UNITED STATES PATENT AND TRADEMARK OFFICE

APPLICATION NO.	FILING DATE	FIRST NAMED INVENTOR	ATTORNEY DOCKET NO.	CONFIRMATION NO.
10/776,906	02/11/2004	Rens Hansort	092301-9013 US001	3072

Office Action Summary

DETAILED ACTION

Fig. 2

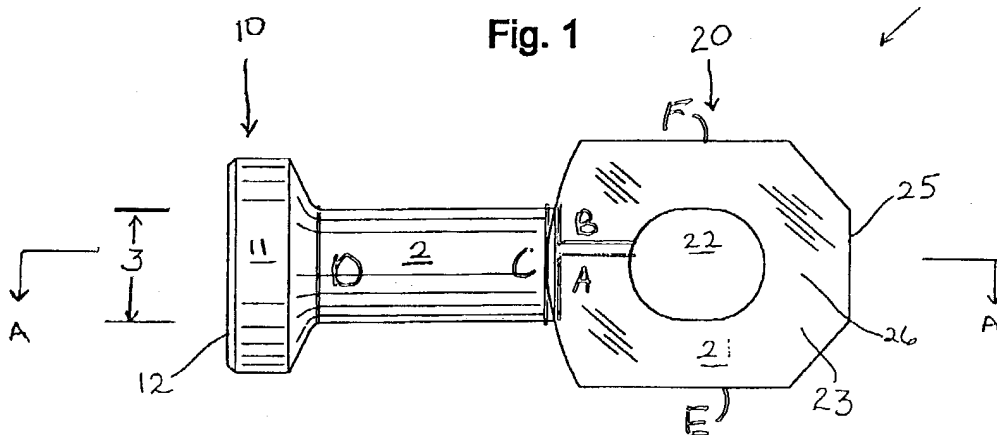
Regarding claim 1, Scott shows a bar (26) having a first end (A), a second end (B) positioned adjacent the first end, and an intermediate portion curved to at least partially define an aperture (22) and a stem (2) having a first end (C) coupled to the first end and the second end of the bar, and a second end (D) coupled to a foot (to left of D) (Fig. 2, 3).

Regarding claim 2, Scott shows the bar, the stem and the foot are integrally formed (Fig. 2, 3).

Regarding claim 3, Scott shows the bar further comprises a first flat side (E) and a second flat side (F) defined in an outer portion of the bar (Fig. 2, 3).

Regarding claim 4, Scott shows the first flat side is positioned opposite the second flat side with respect to the aperture (Fig. 2).

Regarding claim 5, Scott shows the first flat side and the second flat side are oriented substantially vertically (if Fig. 2 was rotated 90 degrees) (Fig. 2).

Regarding claim 9, Scott shows the aperture is further defined by the upper end of the stem (Fig. 2).

Regarding claim 11, Scott shows the aperture comprises at least one of an attachment aperture, a reinforcement bar aperture, a shear plate aperture, passthrough aperture, and a combination thereof (Fig. 2).

Regarding claim 12, Scott shows the foot is substantially frustoconical (Fig. 2).

Regarding claim 13, Scott shows the stem is substantially cylindrical (Fig. 2).

Regarding claim 14, Scott shows a ring-shaped bar (26) at least partially defining an aperture (22) therethrough, the ring-shaped bar having a first end (A), and a second end (B) positioned adjacent the first end; and a foot (2) coupled to the first end and the second end of the ring-shaped bar (Fig. 2).

Regarding claim 15, Scott shows a stem (2) having a first end (C) and a second end (D), the first end of the stem being coupled to the first end of the ring-shaped bar and the second end of the ring-shaped bar, and the second end of the stem being coupled to the foot (to left of D) (Fig. 2).

Regarding claim 16, Scott shows the aperture is further defined by the first end of the stem (Fig. 2).

Regarding claim 17, Scott shows the ring-shaped bar further comprises a first flat side (E) defined in an outer portion of the ring-shaped bar, and a second flat side (F) defined in an outer portion of the ring-shaped bar (Fig. 2).

Regarding claim 18, Scott shows the first flat side and the second flat side are positioned opposite one another with respect to the aperture (Fig. 2).

Regarding claim 19, Scott shows the first flat side and the second flat side are oriented substantially vertically (if Fig. 2 is rotated 90 degrees) (Fig. 2).

Regarding claim 24, Scott shows the aperture as an attachment aperture, a passthrough aperture, a reinforcement bar aperture, a shear plate aperture, and a combination thereof (Fig. 2).

Regarding claim 8, Scott shows the aperture has a vertical height, and wherein the first flat side, the second flat side are positioned generally centrally with respect to the vertical height of the aperture (Fig. 2). Applicant fails to show criticality for the first indentation and the second indentation positioned generally centrally with respect to the vertical height of aperture; therefore, it would have been an obvious design choice for the indentations to be positioned generally centrally with respect to the vertical height of the aperture.

Fig. 3

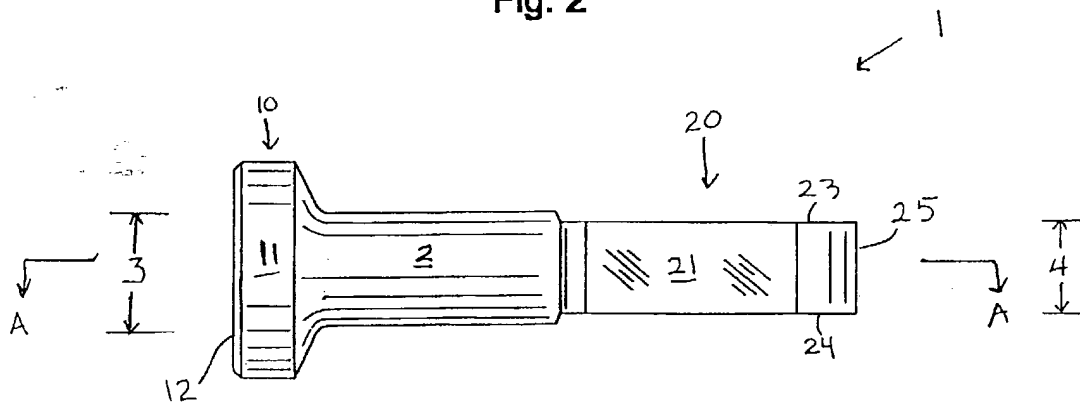
See Fig. 2, 3, attached.
